Access Compliance Report Public Rights-of-Way (Curb Ramps)

Main Street: BALLANTINE_DR Cross Street: KEMPTON_DR Location: NE

ADA ID: RPRK211221130747 Ramp Type: Type 1 - Perpendicular Diagonal Initial Pass/Fail: Fail Overall Compliance: No Severity Score: 16

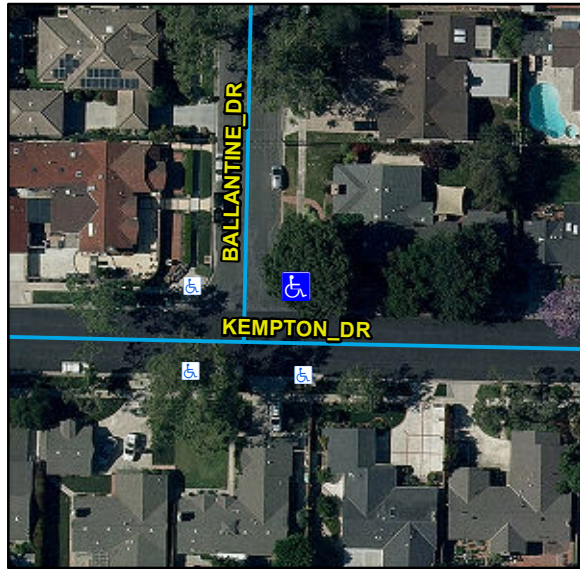
R304.2.2, R204.3, STD 1115

Remove & Replace Curb Ramp With Two New Directional Ramps or Equivalent.
